Summary	Replacing the Syrelec BDRU with the Crouzet MLR1 repeat cycle timer.				
Products Affected					
Key Word Tags					
Tools/Equipment (If Required)					
Parts/Materials (If Required)	CROUZET TIMER 24-240 VAC COIL R0011742				
Related Media					
Author	S. Haipek, RevA M. Burzlaff	Issue Date	3/28/2000	Status	Active

The Syrelec/Crouzet Company has discontinued the BDRU 110Vac/24Vac repeat cycle timer and replaced it with the Crouzet MLR1. The obsolete BDRU timer required a jumper between A2 & A3 to operate at 24Vac. The new MLR1 operates from 24 to 240Vac, thus eliminating the need for the jumper.

Syrelec BDRU timer

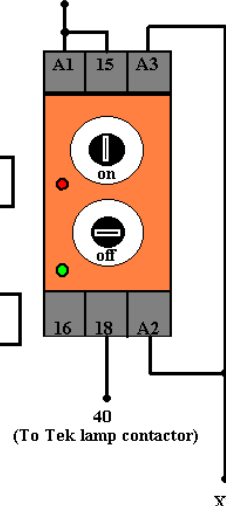
110Vac or 24Vac/dc

24 to 240Vac or 24Vdc

The green LED on the new timer will blink "ON" for a very short period of time when Toff is timing and for a longer duration when Ton is timing
